Cover Note – Non Material Amendment to PL/2022/09425 – Land at Elm Grove Trowbridge – February 2026 (Rev A)

The application requests the substitution of approved plans to reflect changes necessary to the scheme following a detailed review of engineering details, specifically in relation to the design and location of the sub-station, the underground elements of the pumping station and minor amendments to private driveways.

An overlay of the approved RM planning layout (orange) and the proposed changes below (black) is provided below.

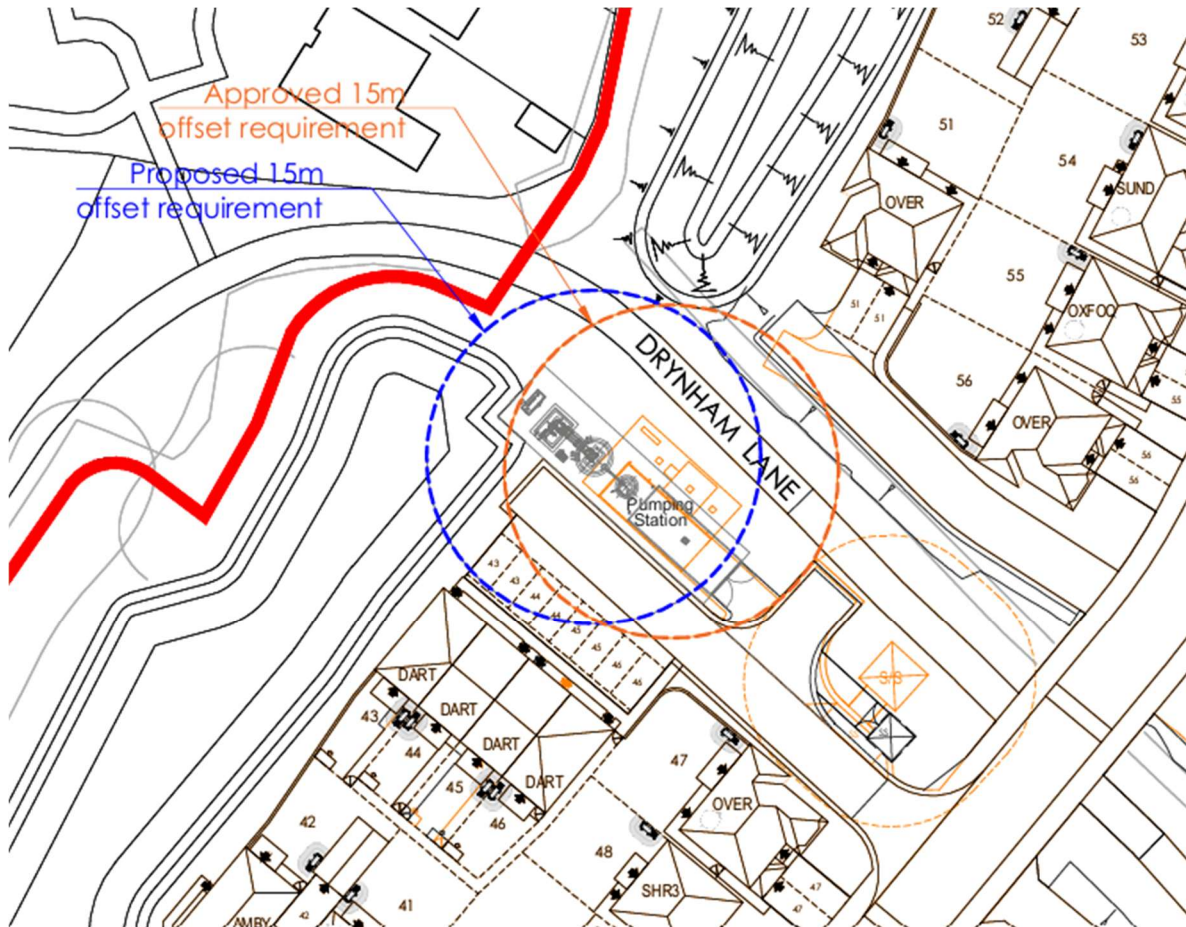
The extract below shows how the pump station and substation have been repositioned to fit within the registered title (green land)

The pump station arrangement has needed to be elongated, and as such a very minor encroachment into the attenuation basin has been required. We include associated calculations and a statement from JRC to demonstrate this encroachment has no material impact on the performance of the attenuation basin or storage capacity.

The title issue means that we have needed to make minor amendments to the position and layout of these assets as shown on the new plans. In order to fit the substation in the allowable space, it needs to be reduced in its footprint. Due to the limits on available footprint and the need maintain a minimum distance to the proposed residential properties, the external appearance has had to change from the approved brick to GRP. There isn't sufficient space to house the sub-station in brick work.

The plan extract below shows a cross section of the proposed installation, with the red line representing the ground. This shows minimal equipment above ground.

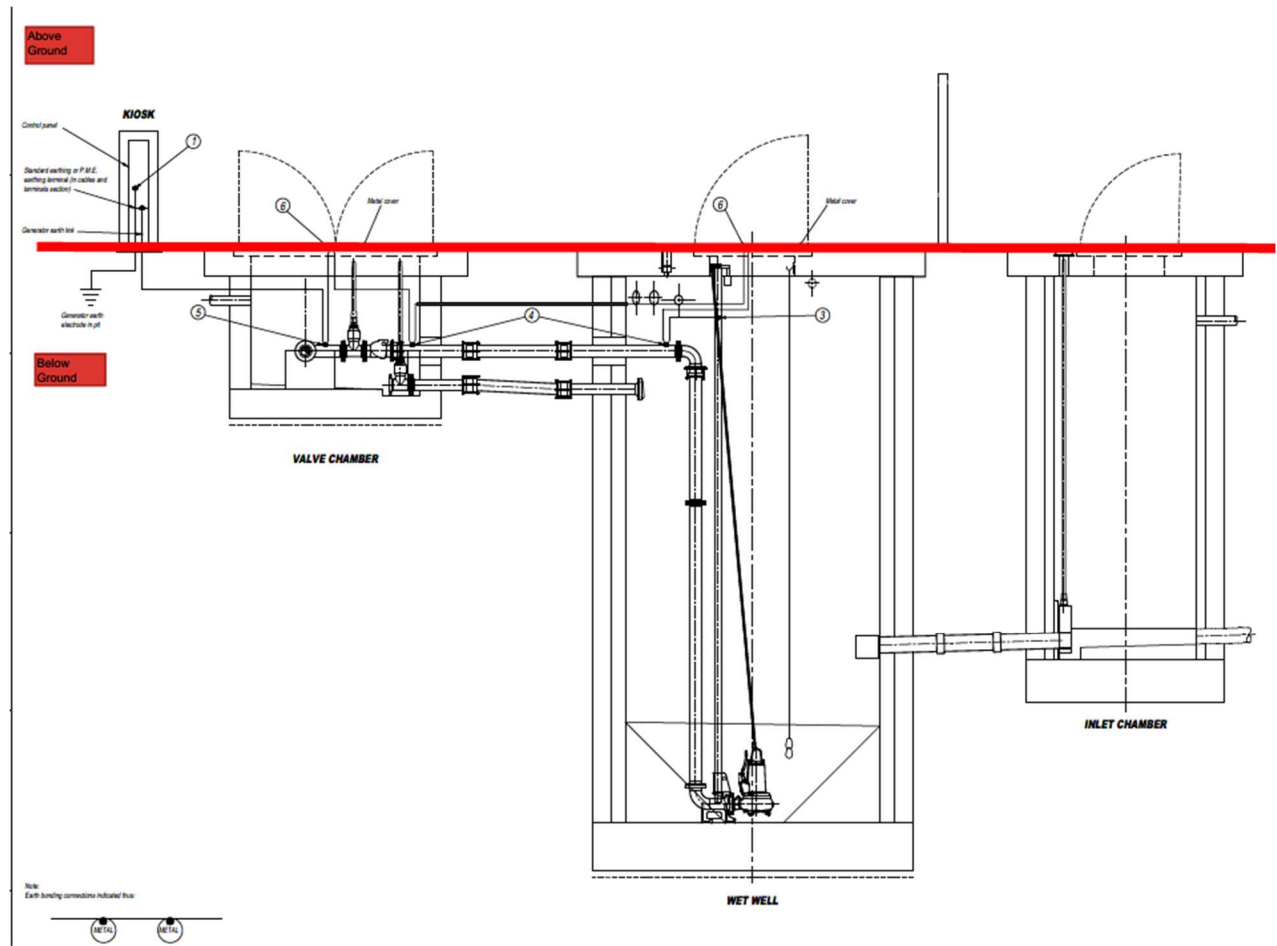
The pumping station is a predominantly underground piece of apparatus.

Proposed Plan Extract

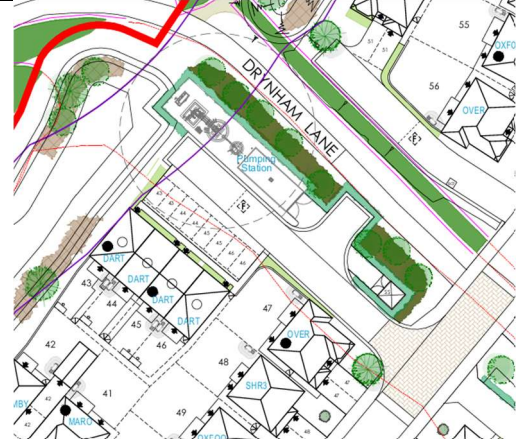
NMA layout required to avoid unregistered land adjacent to Drynham Lane. Allows for additional planting and greater separation to Drynham Lane.

Original RM Landscape Plan Extract

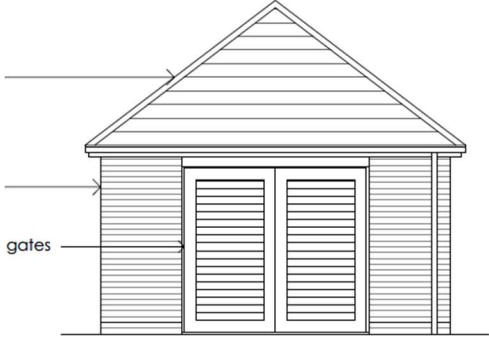
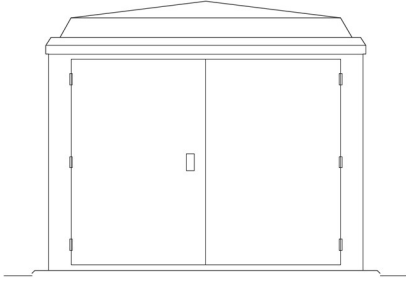
Substation materials revised to GRP (Green) – needed to fit in to smaller available footprint – mitigated through additional planting.

Original RM Planning Layout Extract	Proposed Plan Extract

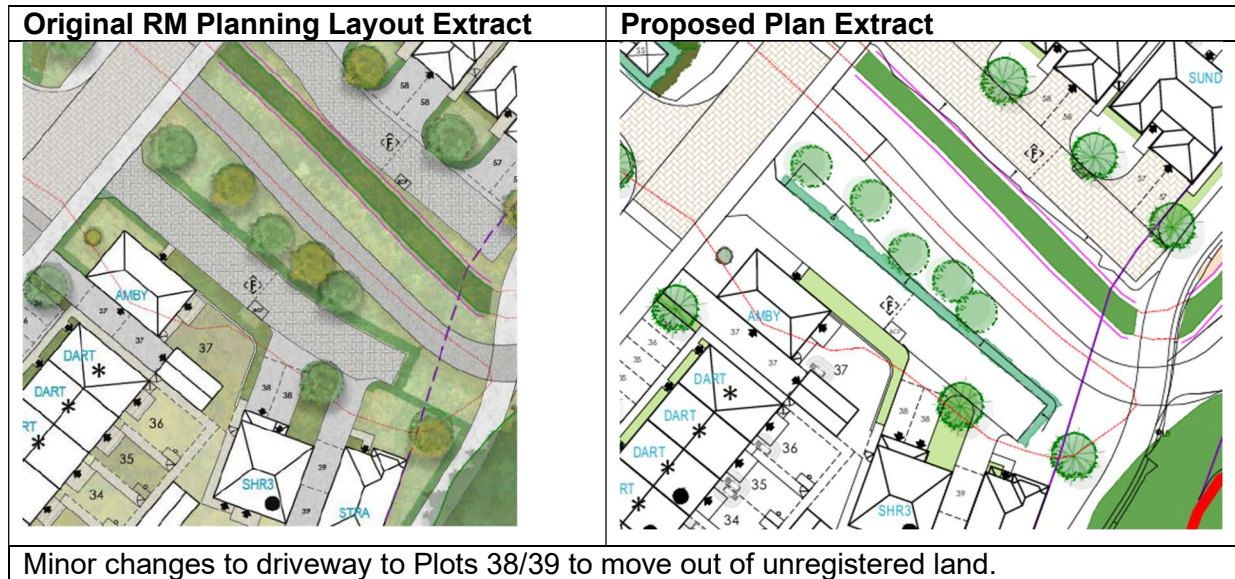
Minor changes to driveway to Plot 51 to move out of unregistered land.
